Service Bulletin

Service Bulletin #2018-01

Re: Initial and recurring Inspection of the Compressor Mount Bracket

Drawing Reference: 01-365-21-100

Figure 1

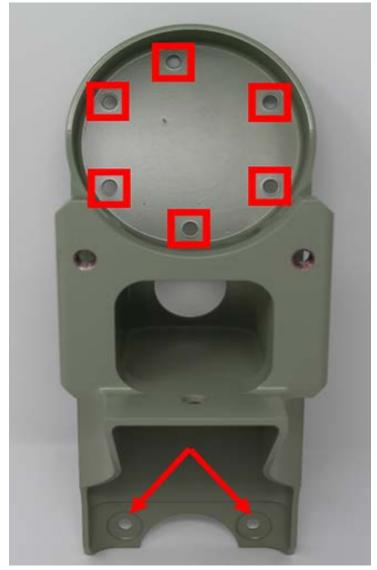
What: Gain access to the aft side of the MGB and locate the Compressor Mount Bracket, P/N 04-365-21-107-01.

Using an inspection mirror and an appropriate light source, inspect the 6 attaching holes at the top end of the bracket for any signs of cracking.

Next, inspect the two attaching holes at the bottom end of the bracket and adjacent to the tail rotor driveshaft for any signs of cracking.

See Figure 1 for inspection locations (highlighted in red).

If any signs of cracking are present at either of these locations, contact RSG Products immediately for replacement.

If a crack is present and it is equal to or less than .25" in length, it is permissible to accumulate a total of 5 additional aircraft flight hours prior to replacement.

If a crack is present and it is greater than .25" in length, immediate replacement prior to further aircraft flight is required.
